Majumder Garments Ltd (relocation) (Extension)

Majumder Center, 113/1, Mudafa Paschim Para, Tongi, Gazipur
(23.901078, 90.366939)

16 October 2024

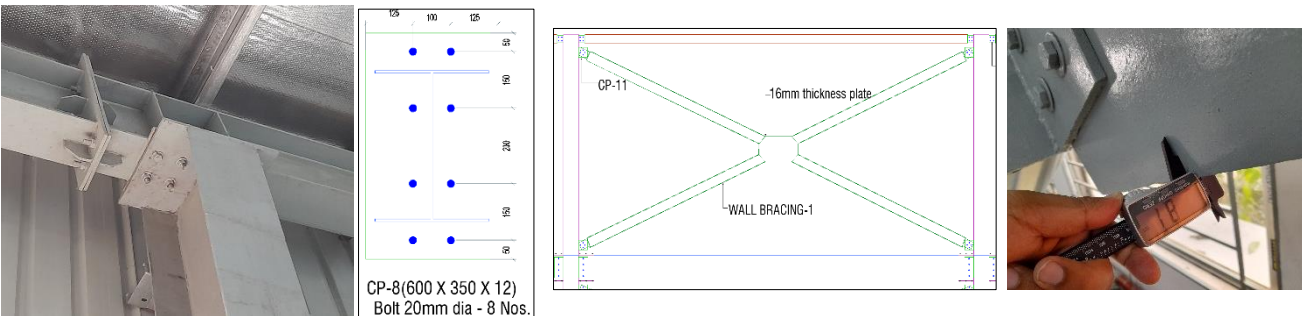
Description: The referred section (marked above) in the DEA report does not match BNBC-2020. The response modification co-efficient, $R=3.25$ has been considered for the structure. The seismic force-resisting system along the east-west direction is the Moment Resisting Frame system. But for the Soil site classification of SD ($S=1.35$) and Seismic design category- D, OMRF is not permitted for the Moment Resisting Frame (BNBC-6.2.19-C). Building engineer is required to clarify the issue. Also for the soil site classification, average Soil properties of 30m in top is required. Provided soil test report was showing the soil boring of 21.34m.

Description: Connection adequacy check for the bracing and other collector members has not been provided in the DEA report. The building engineer is required to revise the prepared design document and submit it to RSC for further review.

Observation-04: Gap found in connection. (Two Storied Steel Shed Building)

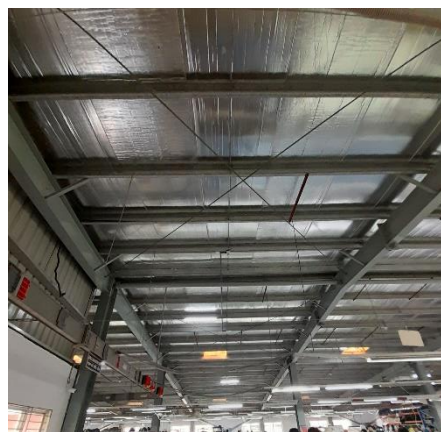
Description: Connection gaps and bolt missing were observed in the steel joint. The building engineer is required to carry out suitable remedial works.

Observation-07: Lack of as-built drawing. (Loading-Unloading shed).

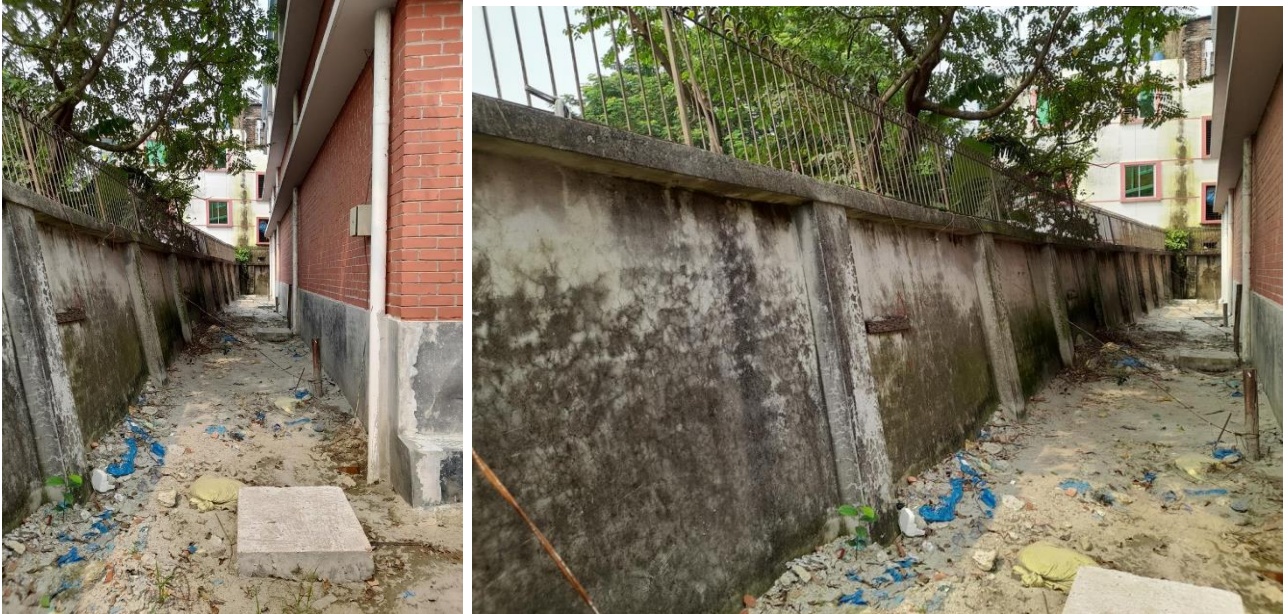
Description: As-built drawings (architectural and Structural) drawings were not available for the loading-unloading shed. Building engineer is required to prepare a full set of as-built drawing for the shed.
